Objection to planning application: 2014/3258/P

74 Camden Mews

Single storey roof extension

Replacement of rear 1st floor window

Figure 4; Thick black line highlights the outline of no 78. Thick red line shows smaller patio of no 76

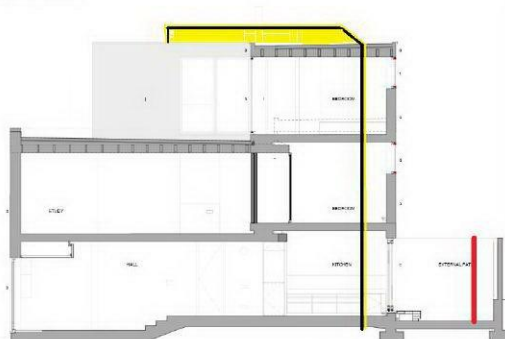
2. The Llowarch's current windows at first floor level are slanted at about 45%. If they build these out so that they are vertical, and then then build another floor on top of this, they will cut out light from the whole of the back of our house.

Their house is already wider than ours, extending further out to the patio at the back. Increasing this wall from the first floor upwards will cut out yet more light from our bedrooms and our living room. The only window in our living room is to the back of the house, we already have a smaller patio than most houses in the street, and this is surrounded by high walls.

Note: our neighbours on the other side – at number 78 were not allowed to build a vertical wall on their extension.
